Road Safety Audit

BusConnects Dublin Core Bus Corridor Infrastructure Works – Package B

Road Safety Audit Stage 1

20/04/2022

Figure 3.1 Northwest scheme tie in

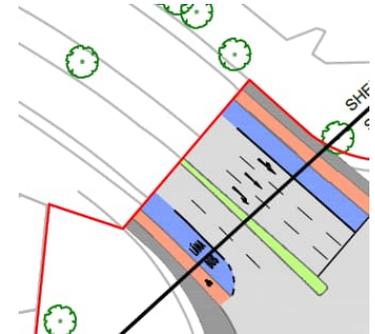
The Audit Team note that on the north-eastern approach to the junction that there are 2 lanes of traffic at the tie in and at the Stop lane. The existing road layout, just outside the scheme extents at the tie-in has an abrupt road widening into 2 lanes. This abrupt widening with missing kerbing may lead to an increased risk driver confusion (Figure 3.2).

The design team should make provision for controlled pedestrian movements across this arm.

Figure 3.3 Access to Fitness Centre

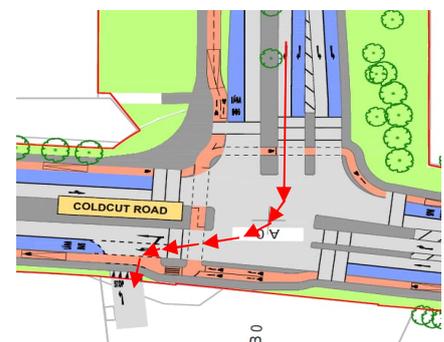
It is noted that there is a left turn access for Liffey Valley Fitness (Figure 3.3). The Audit Team is concerned that motorists from the north wishing to access this facility may conflict with a bus mid junction resulting in a sideswipe type collision.

Figure 3.11 Cycle lane raised across private access

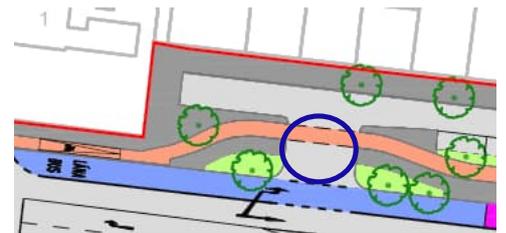
The Audit Team note the cycle track diverges away from the main carriageway at chainage B2150. At this point the cycle track ramps up but, in the absence of a raised table here, it is not clear at what level the cyclist crosses the private access. The Audit Team are concerned that the abrupt level difference will be imperceptible to vehicle approaching. (Figure 3.11).

Figure 3.13 Raised Table

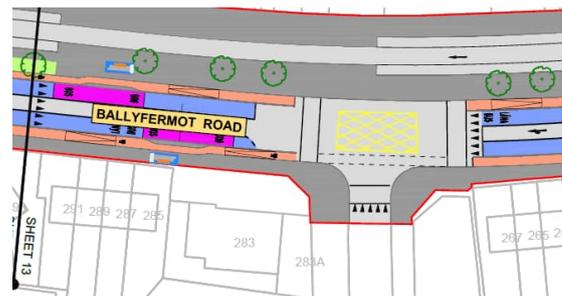
A raised table is indicated between chainage B2570 and B2750. Within the raised table, ramped cycle tracks are proposed. In the absence of drainage drawings, the Audit Team is concerned that water will pond between the raised table and adjacent ramps for cycle track causing a slipping hazard during cold conditions.

Figure 3.15 crossing and cycle track ramps

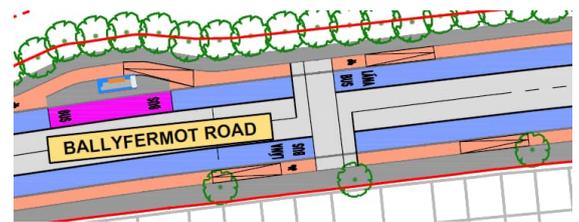
The Audit Team note that a signalised crossing is proposed outside number 171 Ballyfermot Rd. The Audit Team is concerned that the locations of the ramps, with regard to vehicular accesses on the southern side of Ballyfermot Rd and proximity to the island bus stop at the north may result in an increased risk tripping hazards for pedestrians or difficulties for motorists in accessing driveways.

The Design Team should review the desire lines at this location and either consider a raised table crossing to remove the cycle track ramps or relocate the ramps appropriately.

Figure 3.37 New Cycle Track

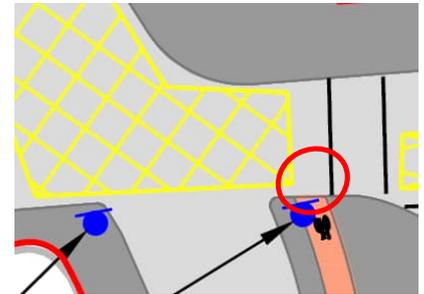
1. Cyclists making dangerous maneuvers to access this with associated risks of being struck by a vehicle;
2. Cyclists striking the ill-positioned 'Tram Only' pole on entry;
3. Cyclists getting stuck in the parallel recessed tram tracks trying to enter the new cycle track;
4. Pedestrians using the existing pedestrian crossing over the Tram Lane to the west of this island may be struck by cyclists.

Figure 3.42 Vehicle Swept Path

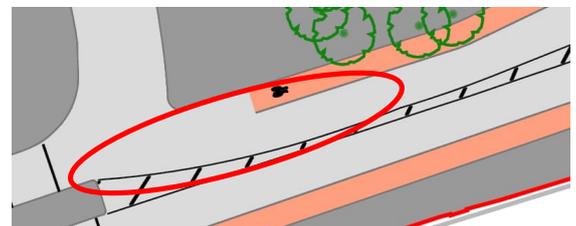
It is noted that there is a new inbound cycle lane at B7750. In the absence of swept path analysis, it is not clear if vehicles (particularly buses) can adequately navigate past the commencement of the cycle lane. The Audit Team are concerned that cyclists may be sideswiped by buses.

Figure 3.43 In-line Bus Stops

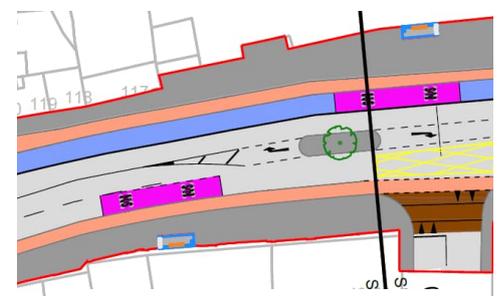
It is noted that there are a number of inline bus stops proposed between Chainage B7850 to 8700 (Sheets 25 to 27). In the absence of further detail, it is not clear if passengers should board/alight from the bus on the cycleway. The Audit Team are concern this will result in an increased risk of conflict between pedestrian/passengers and cyclists.

Figure 4.8 Lack of proposed signals

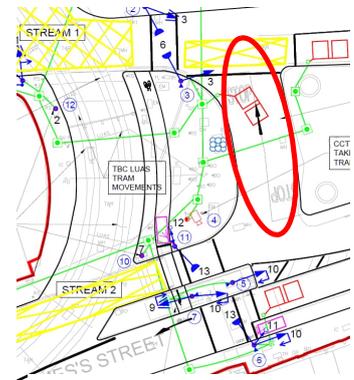
The Audit Team is concerned that there are no primary or secondary signal heads proposed on the junction arm shown in Figure 4.9. There is an increased risk of vehicles overshooting the junction leading to vehicular collision.

The design team should ensure that the road markings approaching the junction are appropriate.

Figure 10-3 - Existing desire line/ existing uncontrolled crossing

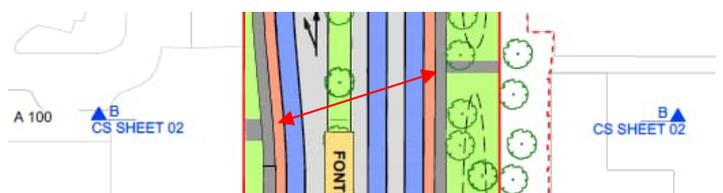
There is currently an uncontrolled pedestrian crossing at chainage A110 between two opposite pedestrian accesses on Fonthill Road, which is proposed to be removed as part of the design. This may lead to pedestrians crossing where no facilities have been provided. This problem was previously raised as a Problem 3.2.5 in the original RSA.

Figure 10-4 - Existing Public Lighting Configuration

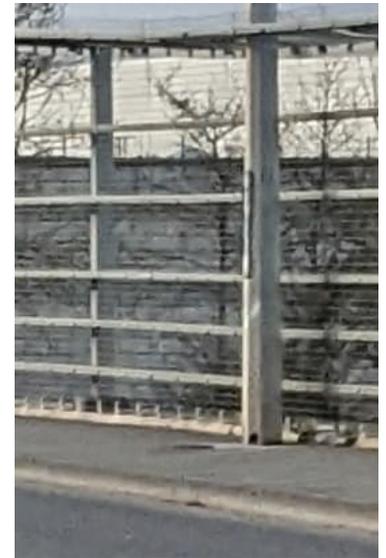
It is proposed that cyclists and pedestrians will share the existing footpath where the Coldcut Road crosses the M50, as per the current situation. The existing footpath on the bridge appears narrow for a shared pedestrian and cyclist facility, particularly on the northern side of the bridge where the available width is further constrained by the presence of two lighting columns located within the footpath. This leads to a risk of conflict between pedestrians and cyclists or cyclists swerving into trafficked lanes. This problem was previously raised as Problem 3.2.3 in the original RSA.

Figure 10-17 - Lack of signage for "quiet street" route

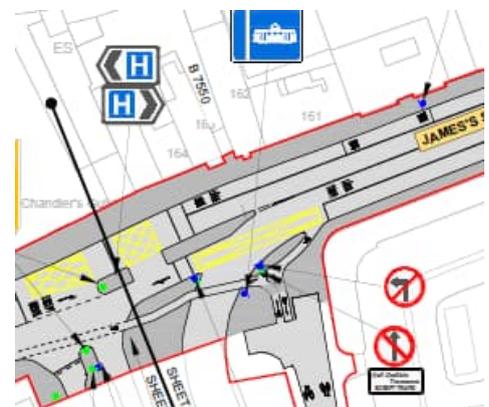
The design includes a proposed "Quiet Street" route for cyclists along Ewington Lane (B 7550), St. James's Avenue, Grand Canal Place and Echlin Street, in place of cyclists using James's Street. The design does not appear to include any advanced directional signage advising cyclists to take this route, which may result in them staying on James's Street, where no provision for cyclists is proposed.

Figure 10-20 - Insufficient Cycle provision to cater for desire lines

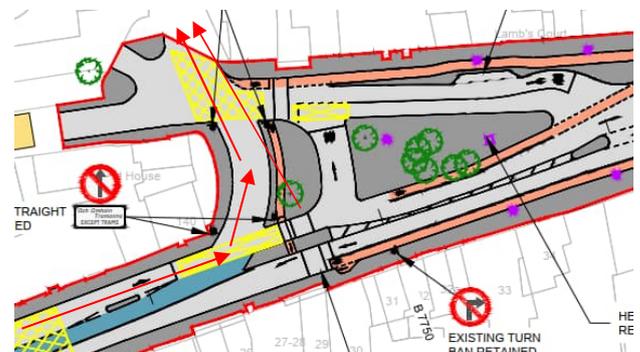
The Design Team noted Bow Lane West would be the preferred route for cyclists heading west from James St. However, it is unclear from the drawings what the proposed cycle route through the junction is from James St to Bow Lane West. There is a single cycle lane through the junction island heading from north to south but no provision is planned from south to north. There is no cycle lane or crossing facility from the central island to Bow Lane West across the LUAS tracks. A lack of clarity for cyclists on the correct route and lack of cycle track facilities through the junction may lead to cyclists making unsafe manoeuvres where there are no facilities provided, leading to risk of conflict between cyclists and vehicles.

Figure 10-21 - Observed Desire Line shown in red

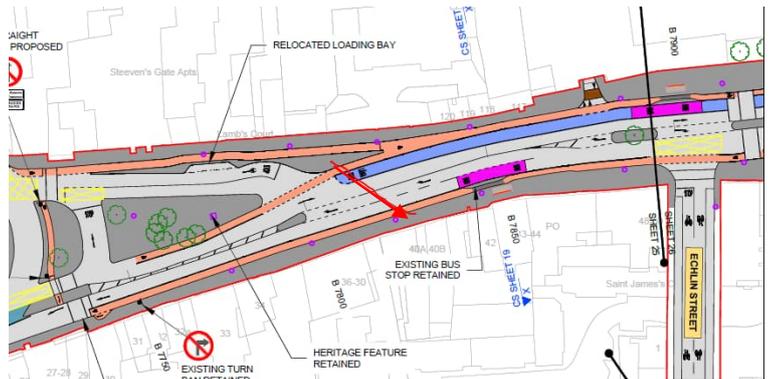
The proposed design at the junction of Echlin Street and James's Street does not include for crossing facilities on the western approach to the junction. Crossing facilities are also proposed at the junction with the Luas tracks at Bow Lane West but these do not align to the desire line of pedestrians wishing to travel to / from James's Street further east. A lack of crossing facilities in this location may result in pedestrians crossing where no facilities are to be provided (which was observed on site where pedestrians utilised traffic islands on James St), increasing the risk of conflict between pedestrians and vehicles.

Figure 10-22 - Lack of Tram Track Signage Eastbound compared to westbound cyclists

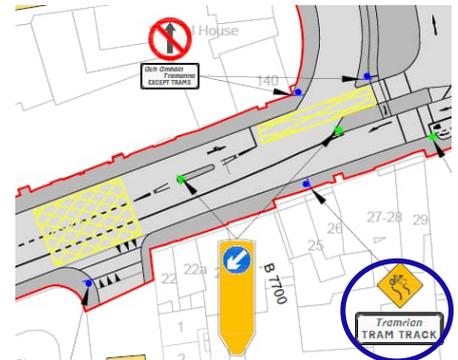
The LUAS tracks turning from James's Street towards Heuston Station (by Bow Lane West), cut across the traffic lane in a curve. Where cyclists are using the traffic lane (not taking the "Quiet Street" option), there is a risk that bicycle wheels may get trapped in the LUAS rails, causing cyclists to lose control.

Figure 12. 4 Lack of flashing amber

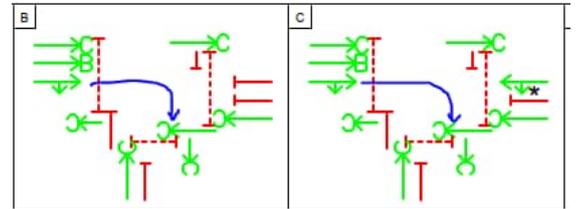
System diagram B and C does not show any * on the right turning movement for traffic from Ballyfermot onto Clifden Road. Lack of flashing amber on the right turn movement will not alert right turning traffic to be aware of cyclist or vehicles continuing straight on Ballyfermot Road in a westbound direction
